RESPONSES TO BETA GROUP, INC. TRAFFIC IMPACT ANALYSIS PEER REVIEW COMMENTS
DATED JULY 16, 2021

RESPONSES TO BETA GROUP, INC. TRAFFIC IMPACT ANALYSIS PEER REVIEW COMMENTS
DATED AUGUST 30, 2021

RESPONSES TO BETA GROUP, INC. TRAFFIC IMPACT ANALYSIS PEER REVIEW – PARE’S
RESPONSE TO COMMENTS NO. 2 DATED NOVEMBER 2, 2021

TURNING MOVEMENTS FOR DELIVERY VEHICLE

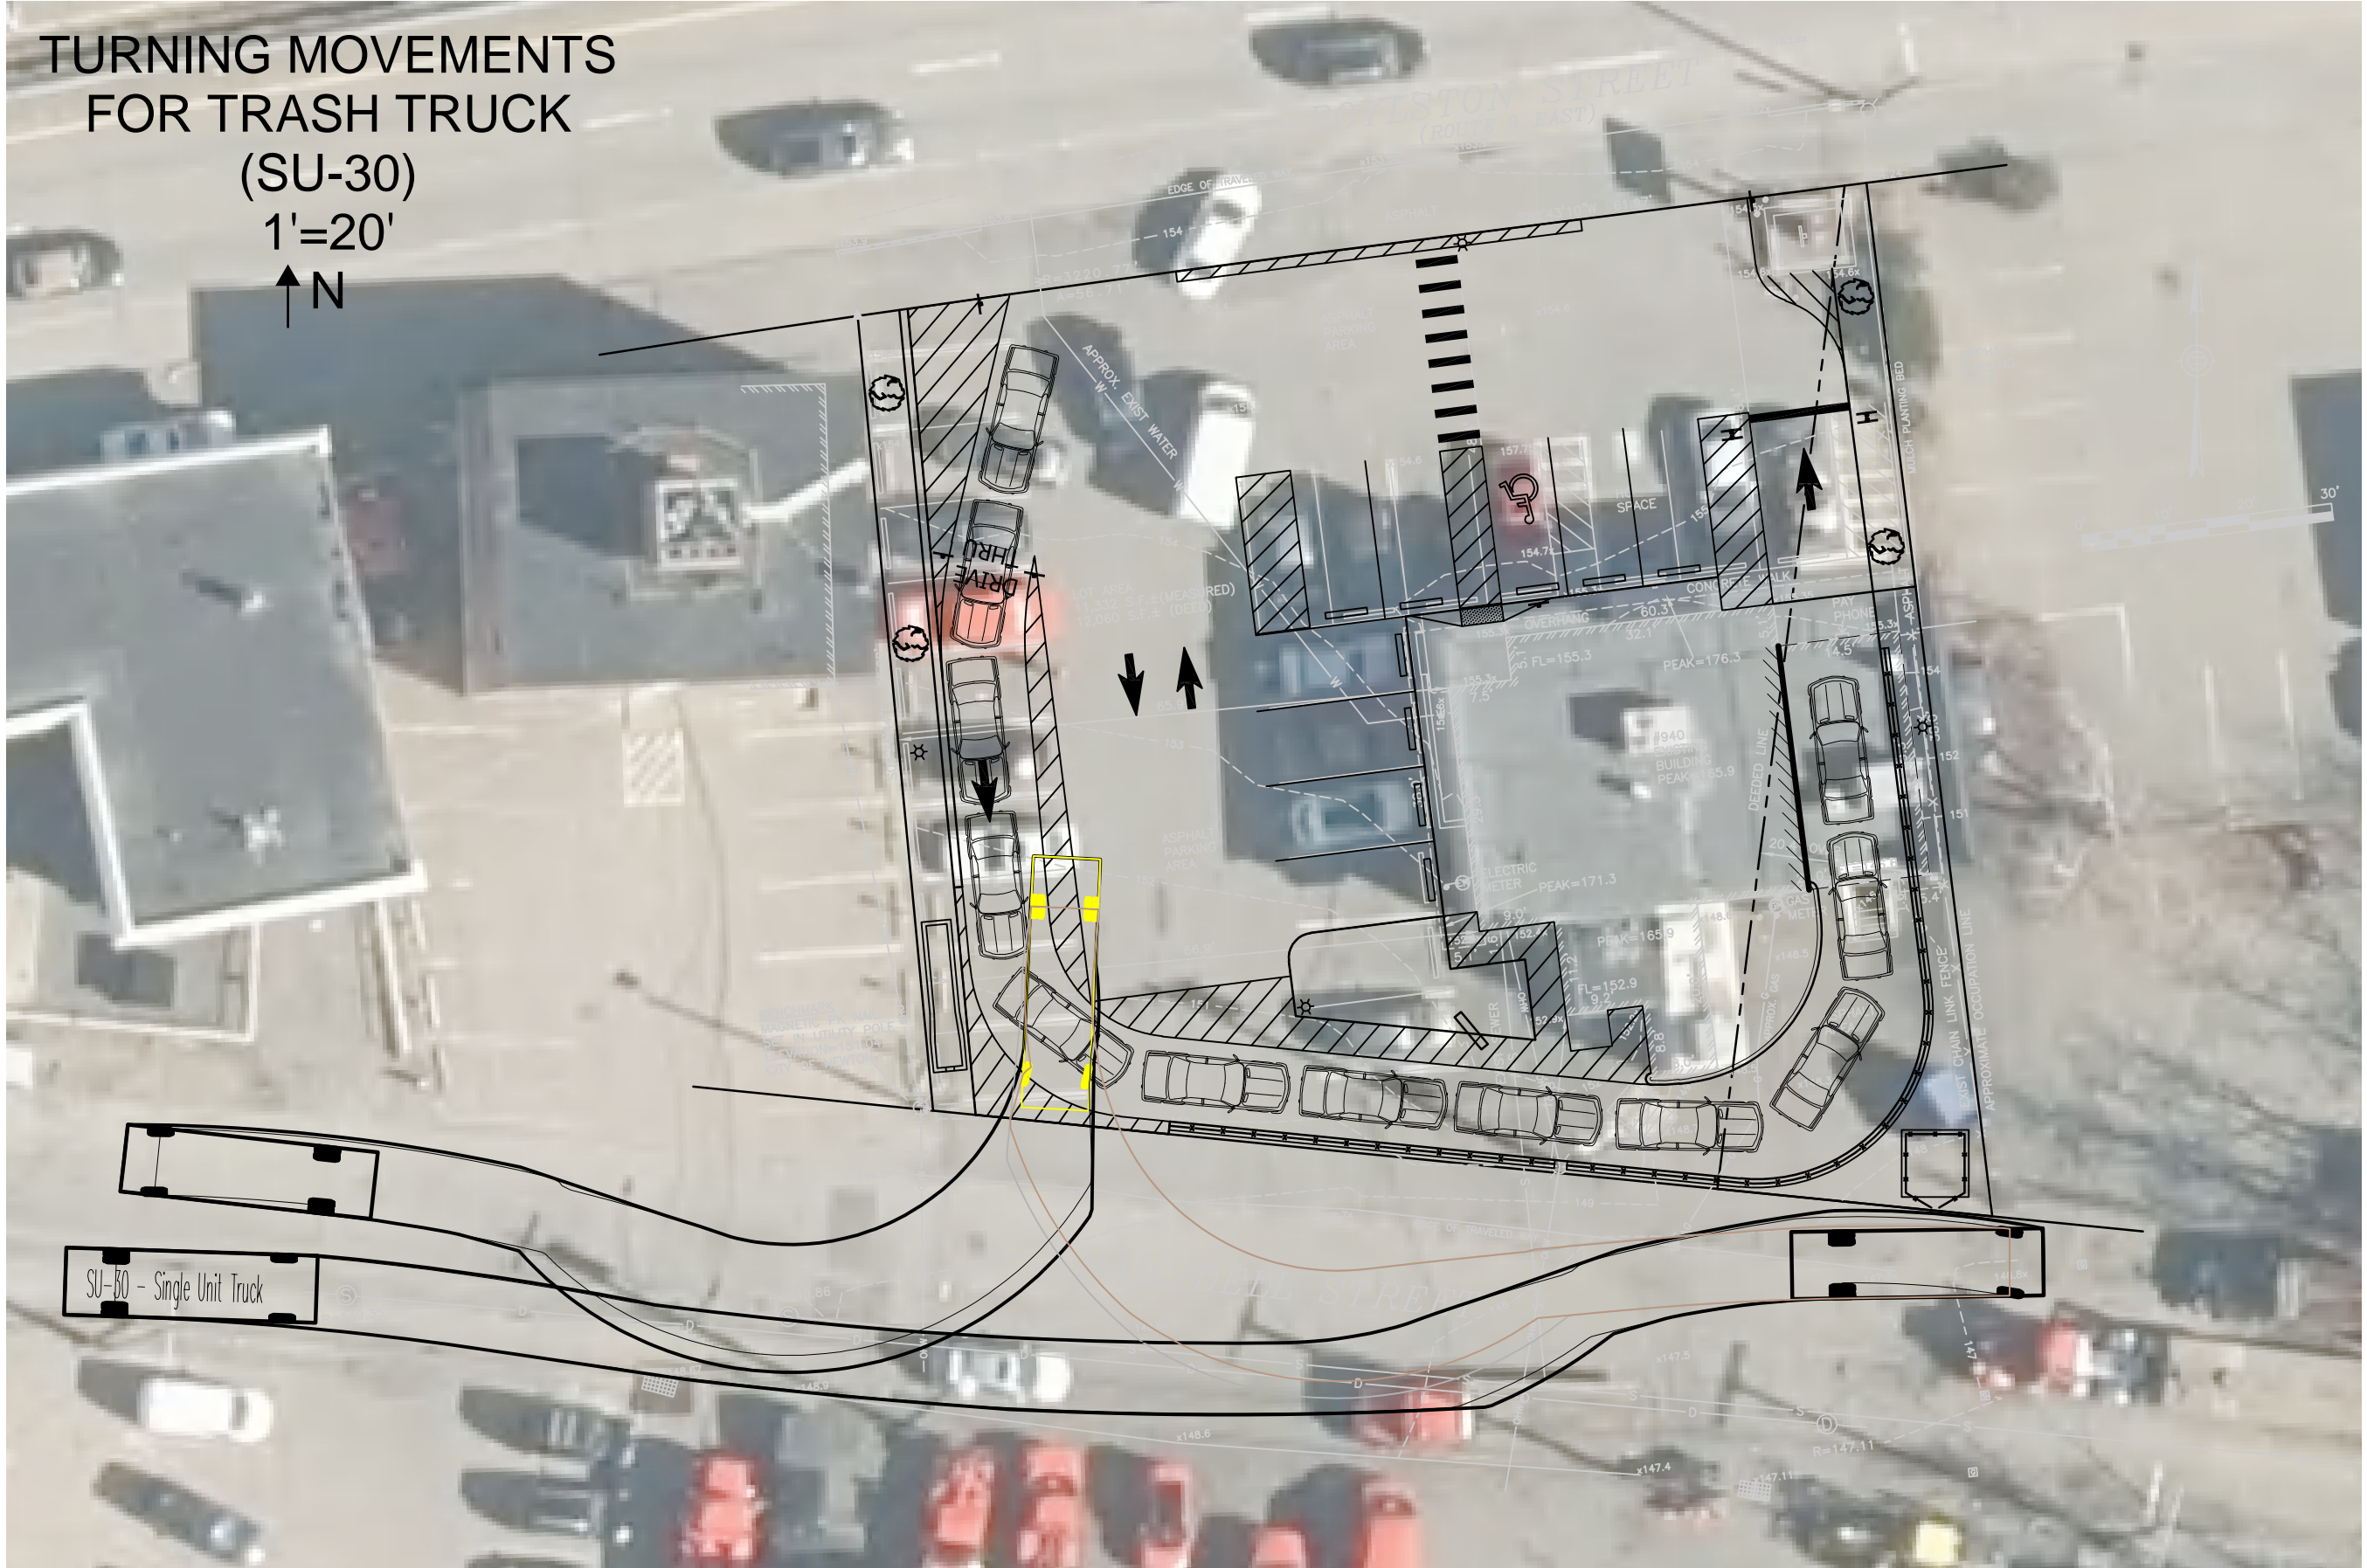
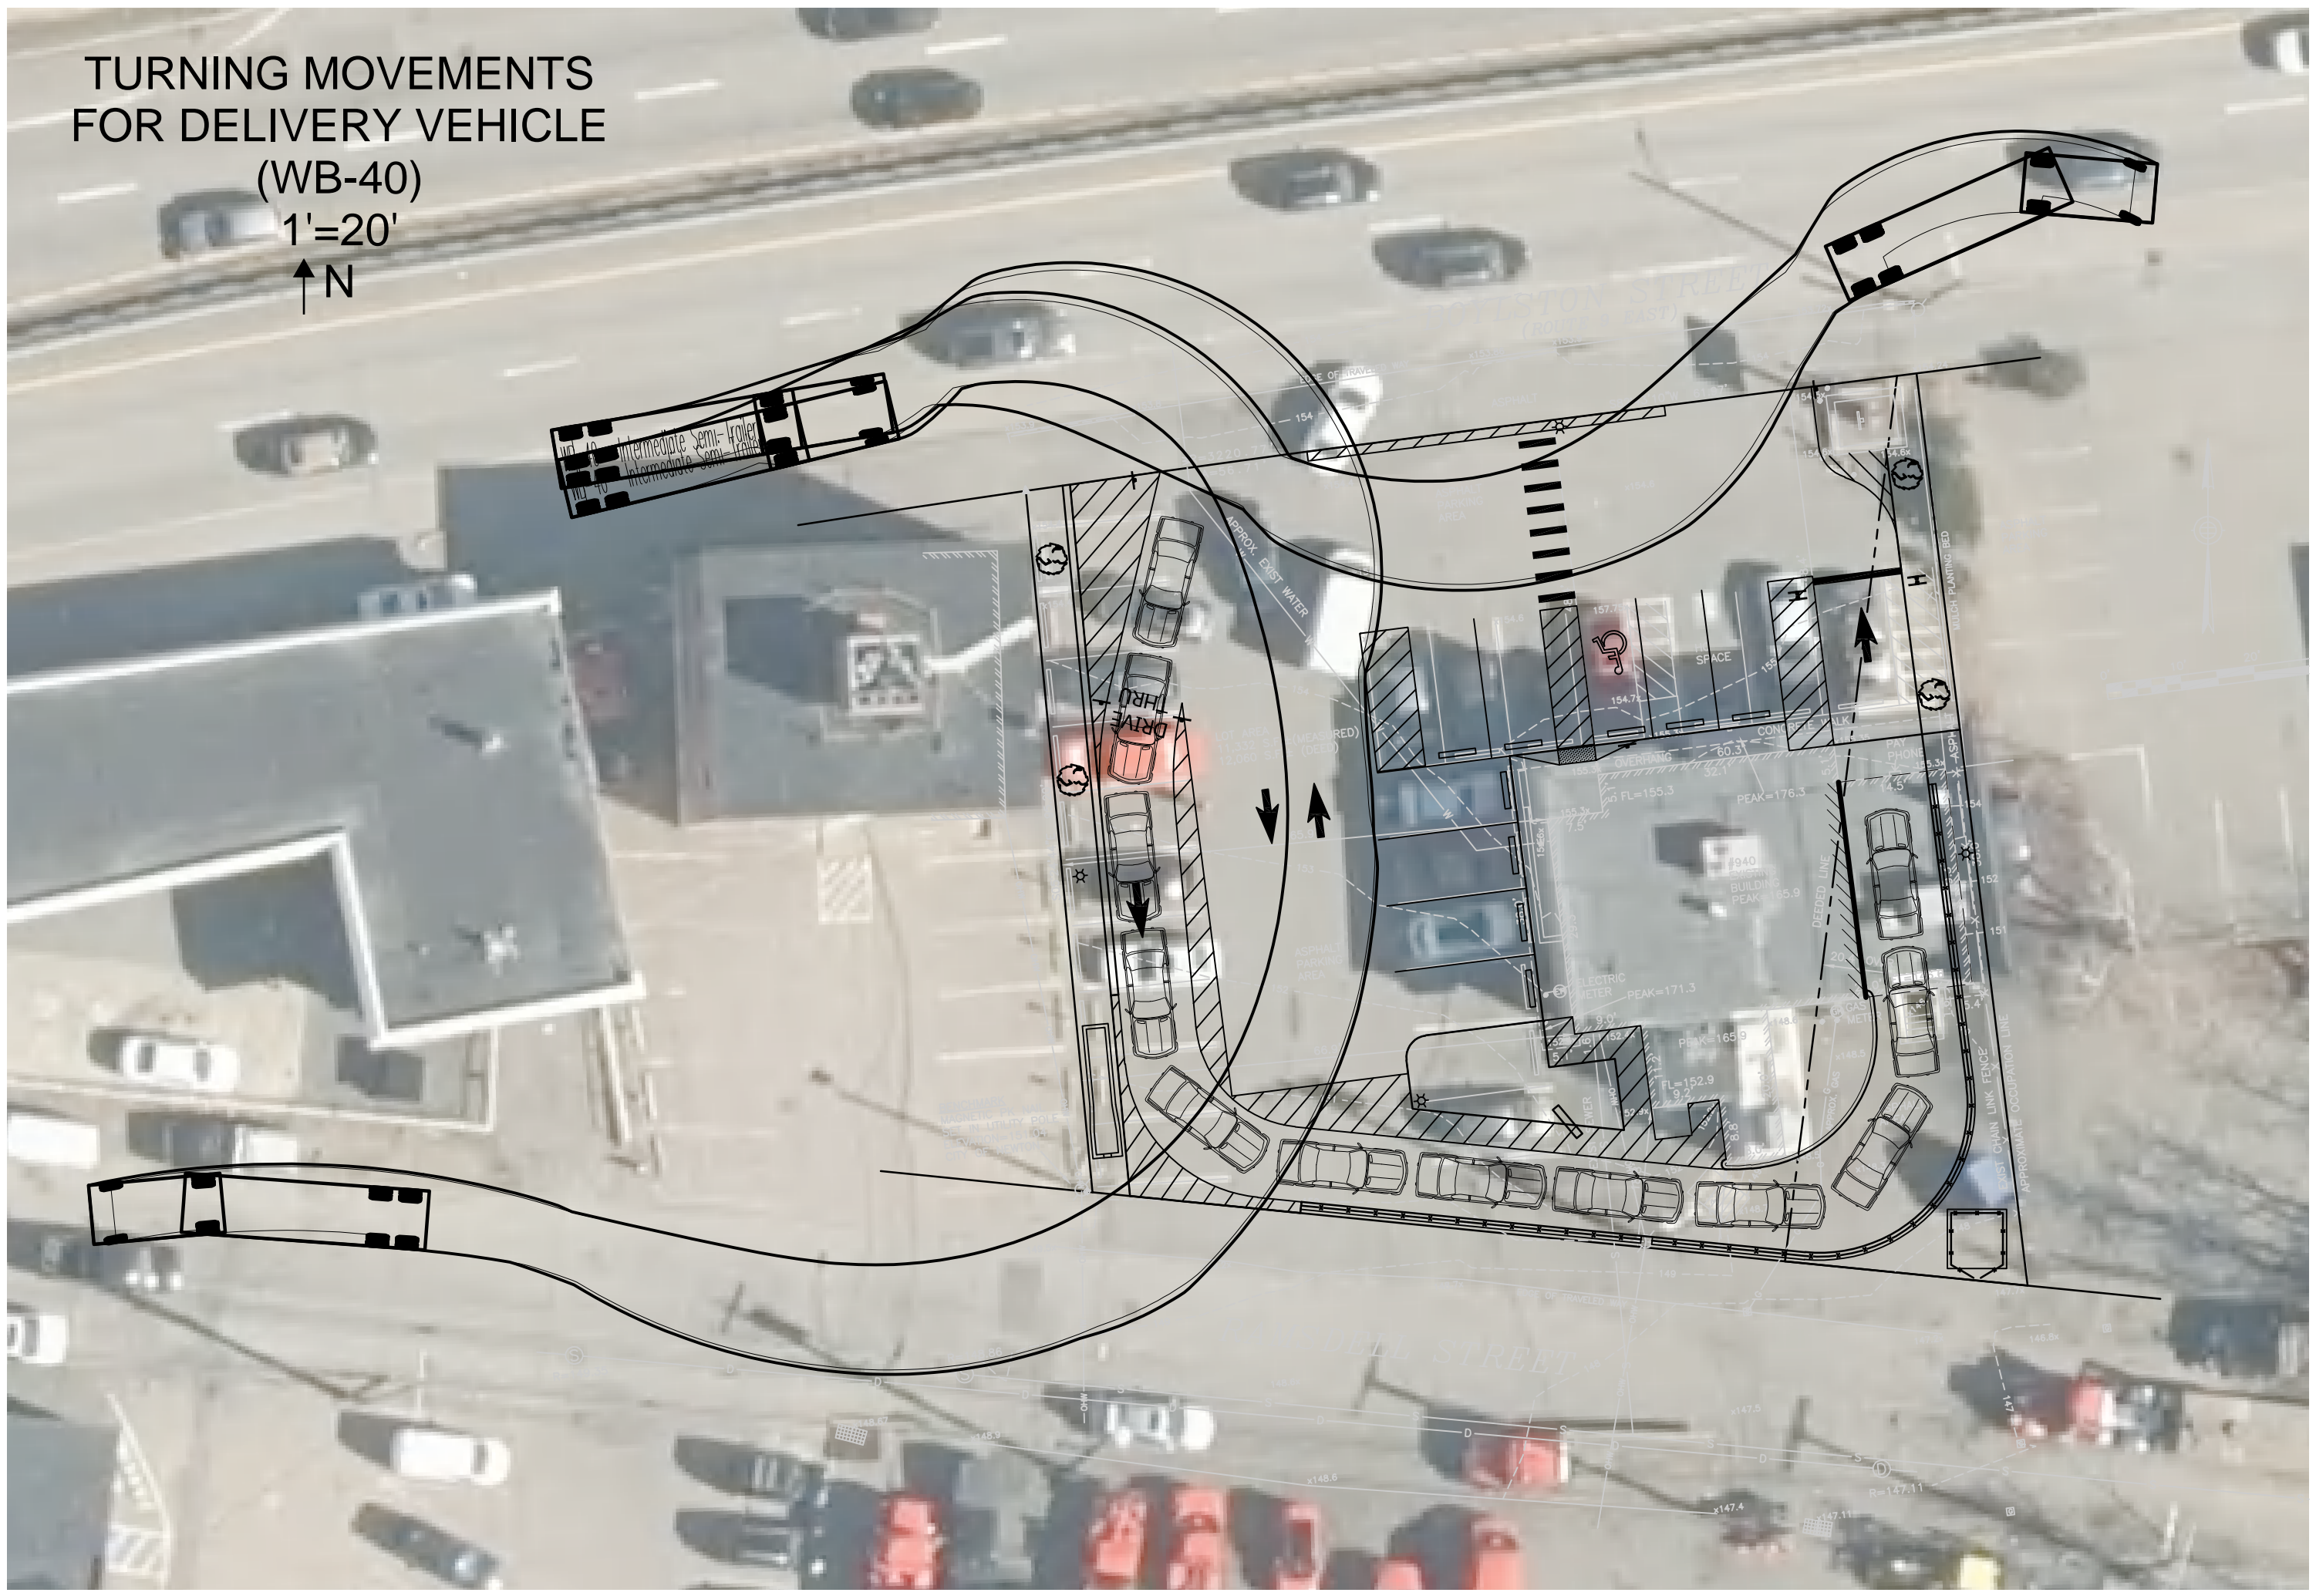
BETA2: Though deliveries are proposed outside the peak commuter hours, Ramsdell Street is a dead-end street with no secondary outlet, which is a concern for larger vehicles particularly large trucks (semi-trailer). What is the typical size of a delivery truck for this site? Please provide a turning template of the delivery truck including the dumpster truck that will access Ramsdell Street. It is important to note that we observed a tractor trailer making a delivery at the Wellesley Dunkin' site within the Route 9 westbound shoulder during the morning peak period.

BETA2: Though deliveries are proposed outside the peak commuter hours, Ramsdell Street is a dead-end street with no secondary outlet, which is a concern for larger vehicles particularly large trucks (semi-trailer). What is the typical size of a delivery truck for this site? Please provide a turning template of the delivery truck including the dumpster truck that will access Ramsdell Street. It is important to note that we observed a tractor trailer making a delivery at the Wellesley Dunkin’ site within the Route 9 westbound shoulder during the morning peak period.

BETA3: Please verify if the WB-40 semi-trailer is the current and future maximum size delivery truck the applicant expects at the subject store. Again, a truck with a 53-foot trailer was observed making a delivery at the Wellesley Dunkin’ site and it’s reasonable to assume that the same truck delivers to other Dunkin’s stores in the area including to the subject store.

PARE2: A turning assessment for a WB-40 semi-trailer and a SU-30 dumpster truck was performed and is provided. The semi-trailer has adequate space to enter from Boylston Street and exit to either Boylston Street or Ramsdell Street. The dumpster truck appears to be side-loaded and accesses the dumpster in a similar manner as it does today.
